ADDENDUM NO. 1

DATE: July 14, 2026

PROJECT: Tull Master Meter Vault
Malvern Water Works
Malvern, Arkansas

CRIST ENGINEERS, INC.	
CONSULTING ENGINEERS		LITTLE ROCK, ARKANSAS	
MALVERN, ARKANSAS			
MALVERN WATER WORKS			
TULL MASTER METER VAULT			
SITE PLAN			
DESIGNED: MPA	JOB NO. 25034	DATE JULY 2026	ADD. NO. 1
DRAFTED: MPA	SCALE: AS SHOWN	REF SHEET 3	
CHECKED: MPA

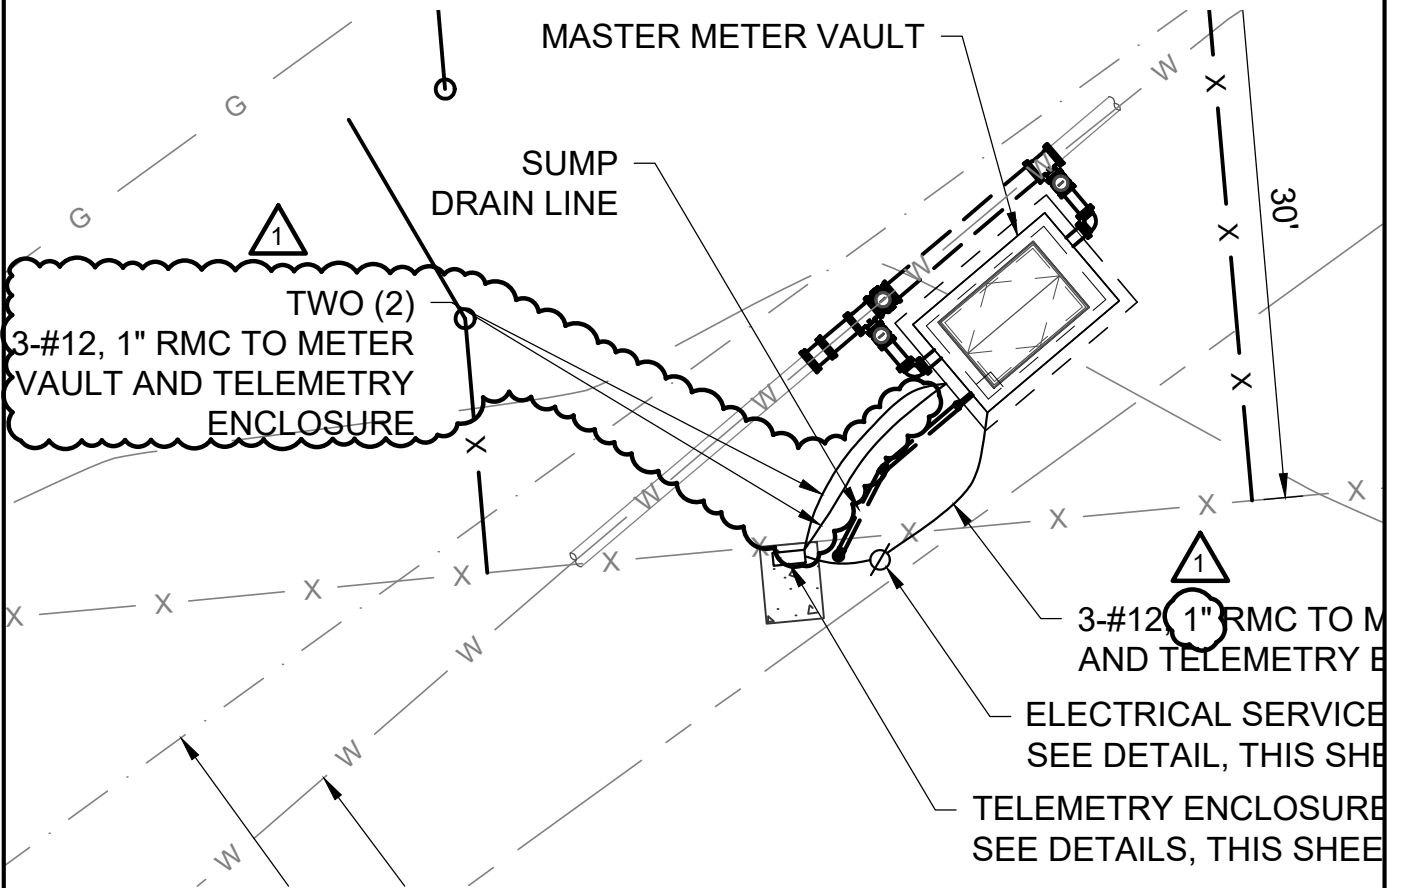
- A. Sheet 3 – Site Plan
 - i. Modify this drawing as shown on the Addendum No. 1 – Site Plan, attached hereto:
